Fw: CUP-R22-0031/ Alhambra Drive Project Objections

Subject: CUP-R22-0031/ Alhambra Drive Project Objections

Aeronautical Study No.
 2022-AWP-21088-OE
 Prior Study No.
 2002-AWP-171-OE

Alhambra Drive Cell Tower Expansion – FAA Part 77 Airspace Analysis

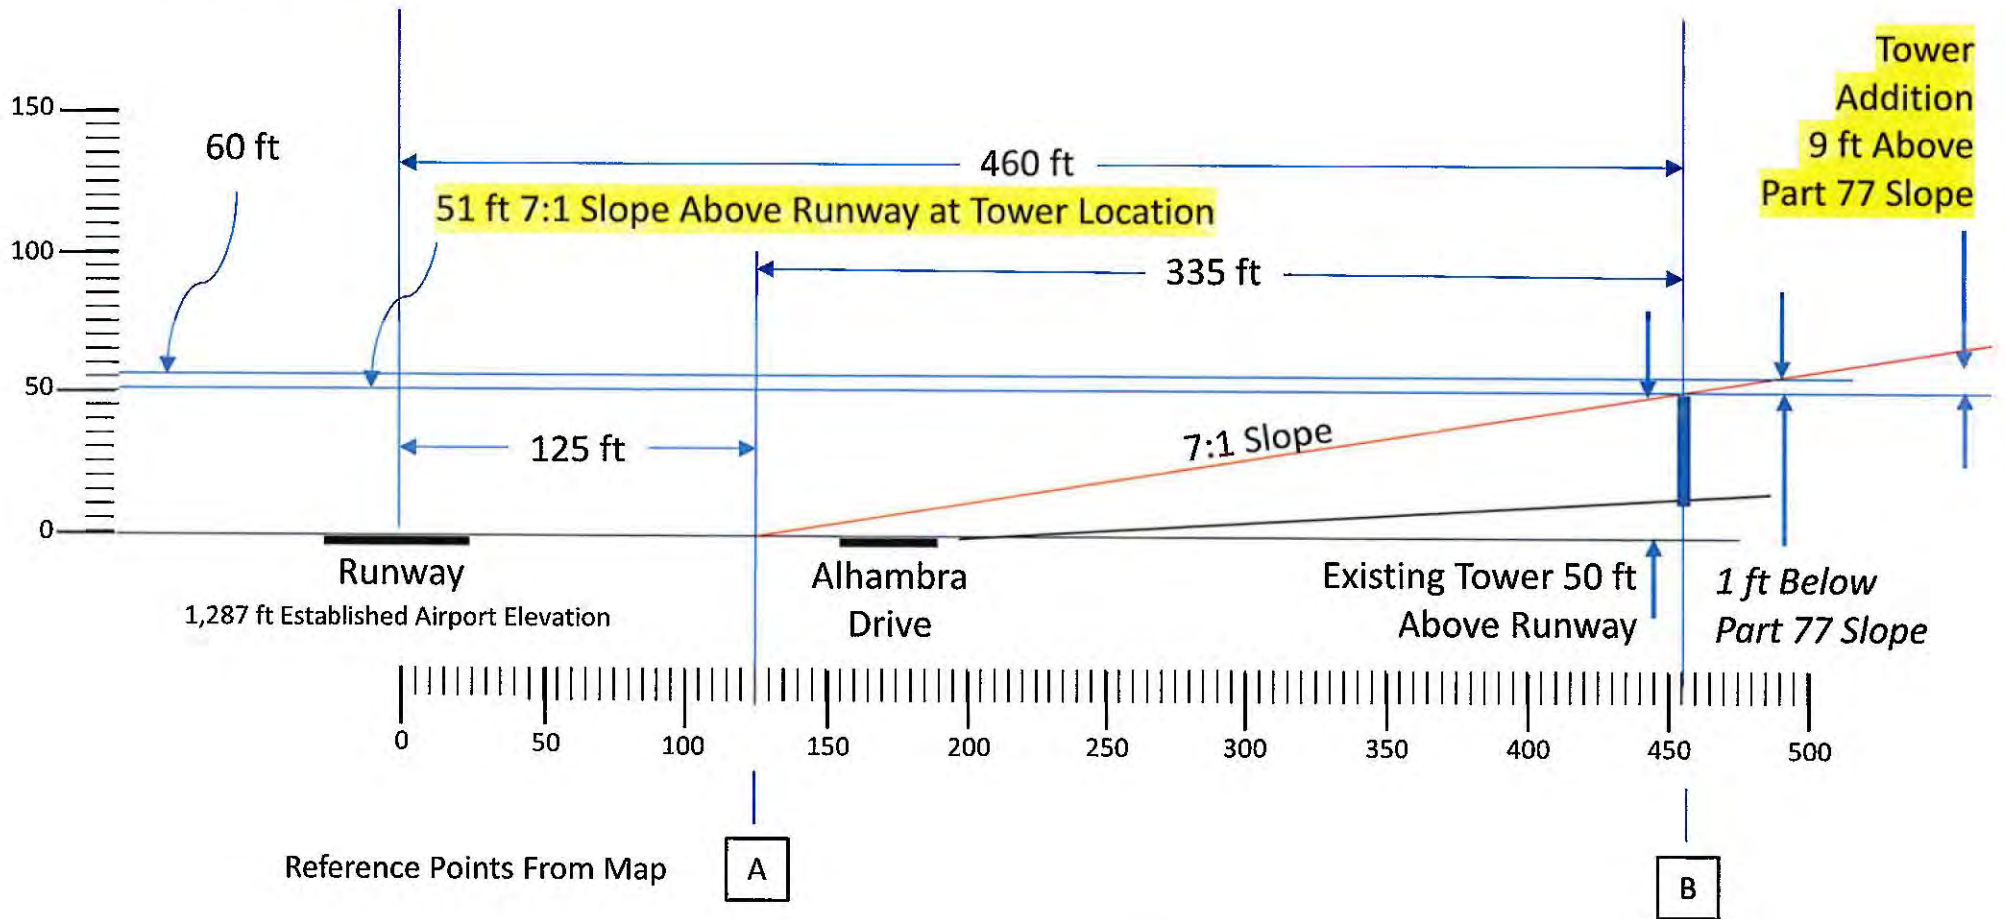
Cameron Park Airport District will be voicing it's concerns with the height of this cell tower and how it violates our FAA Part 77 airspace. While it may have been determined as "no hazard" by the FAA (see attached), CPAD would like to reiterate that any incursion possess a potential risk to airport operations and the original height of the tower was set to ensure that it would not penetrate our airspace. We have attached a basic slide show illustrating how the tower impacts the area parallel to our runway and we will be attending the meeting on April 11 to voice our concerns and to answer any questions.
